Model : Saddle Finisher -D2**Ref. No.** : FF-T01-W-000114-01**Date** : July 7, 2000© Canon (UK) Limited

Location : SADDLE FINISHER**Subject** : MEASURE TO PREVENT CREASE IN FOLDING MODE**Reason** : The shape of the folding roller is to be modified due to possible crease in folding mode.**Details** : <Symptom>
Crease in folding mode.

Figure 1. Folding roller in the saddle finisher

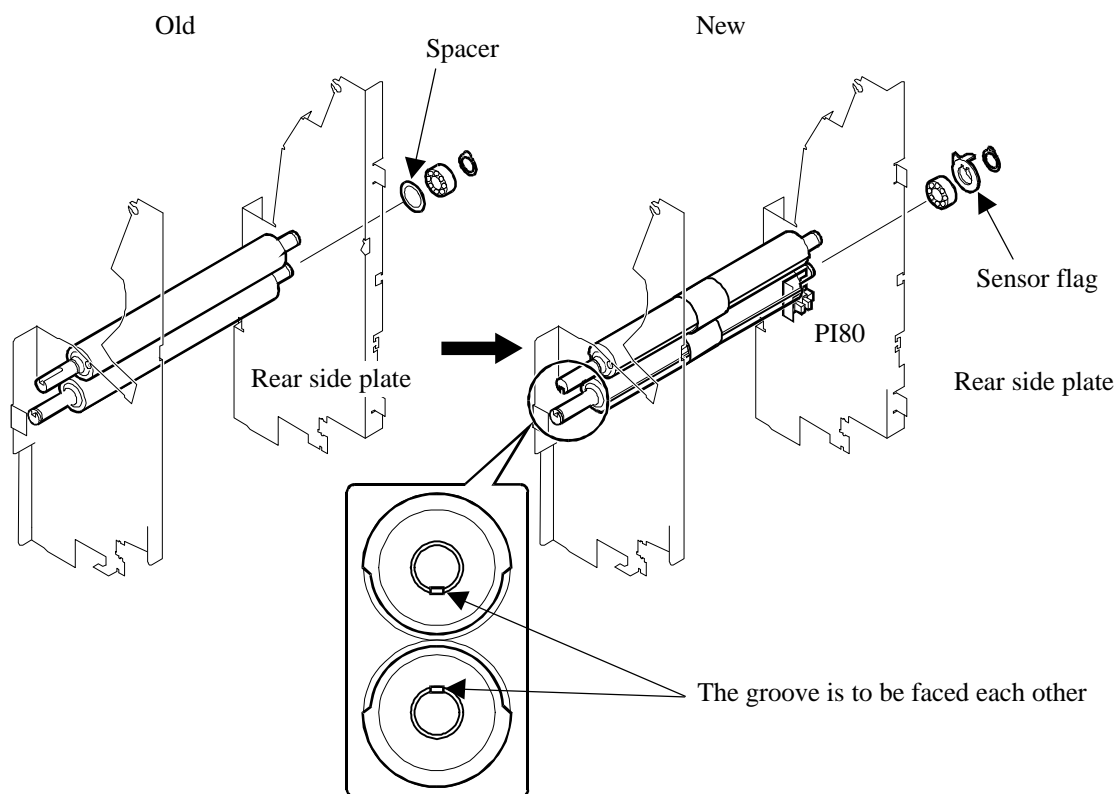
In folding paper, paper is slackened off, which might cause crease.

The shape of the folding roller surface is to be modified so that slack escapes at the end of the folding roller when paper is slackened off.

Due to this modification, the following is to be modified to add the controller detecting the position of the folding roller surface.

1. The sensor detecting the position of the roller surface P180 and the sensor flag (at the lower back of the folding roller) are to be added.
(Due to the addition of P180, the hole for screws to attach the sensor to the rear side plate and cable are to be added in the saddle finisher.)
2. The circuit of the saddle controller PCB is to be modified (addition of J18-3Pin).
Due to the modification in circuit, the PCB no. FH1-2800 is to be changed to FH1-3093.
3. The software is to be modified. (ROM Ver. 3)
Refer to S. Info. FF-T01-W-000110 for the modification of ROM Ver. 3 (FF3-3636-030).

Direction of the upper/lower part of the folding roller in attachment.

- When the folding roller is removed in the modified machine as above-mentioned, the gear is to be attached, with the upper part of the grooves of the folding roller shaft facing the lower part of the groove without fail. When the upper part of the groove is not opposing to the lower part, the following defect may occur:
